**SUBJECT: Environment Act Proposal – SiMBA Sand Extraction Project (Client File No. 6275.00)**

Re: Additional Information Request - Environment Act Proposal, File # 6275.00, Sio Silica Corporation, SiMBA Sand Extraction Project

**Re: Groundwater Management Section Technical Advisory Committee (TAC) Comments  
– 6275.00 SiMbA Project Environment Act Proposal**

Review Figure 1. The Sandilands “coarse-textured deposits” zone is outlined with a dashed boundary.

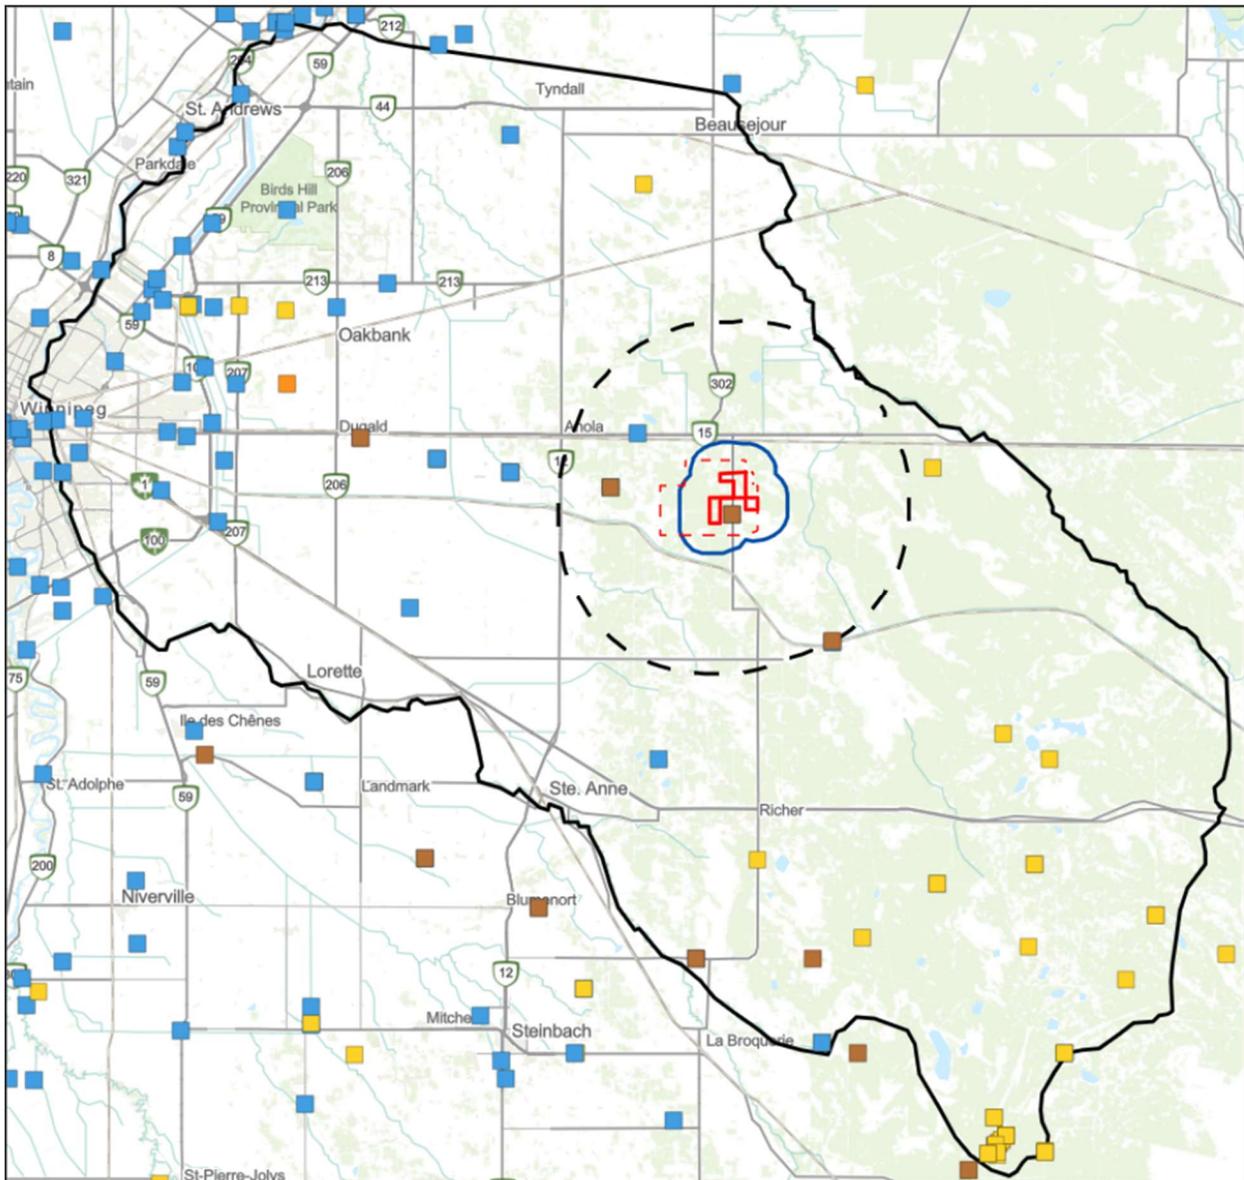
Recharge zones were assigned based on surficial geology but Figure 6-1 likely overstates the extent of the “coarse/high-recharge” areas within the Sandilands region. Recharge zones should be reconciled with provincial mapping, show correlations for before and after in areas, and re-run the steady-state water balance.

<p>“Sandilands area”. Figure 6-1 classifies much of the eastern domain as “coarse-textured deposits” (high recharge), whereas the surficial lithology map (see <b>Review Figure 1</b>) indicates only the southeastern corner comprises these coarser units (use the formal unit names from the map), not the entire eastern area. Over-assigning the “coarse/high-recharge” class would overestimate model inflow and influence calibration and mass balance.</p> <p>Please justify or revise and re-run steady-state mass balance, and report revised recharge totals.</p>
21	APP_B_part_1 – Section 5.8.2 Groundwater Elevations and Gradients – 68	It is unclear if any new wells interconnecting the Red River Carbonate and Winnipeg Sandstone were installed near the observation well that may have affected water levels and vertical gradients.	Any interconnection is far more likely from legacy wells rather than new construction. Under Manitoba Well Standards Regulation, Part 2, 3(1), a person must not construct or seal a well or test hole in a manner that allows the interconnection or mixing of groundwater between the Winnipeg Formation and any overlying aquifer.
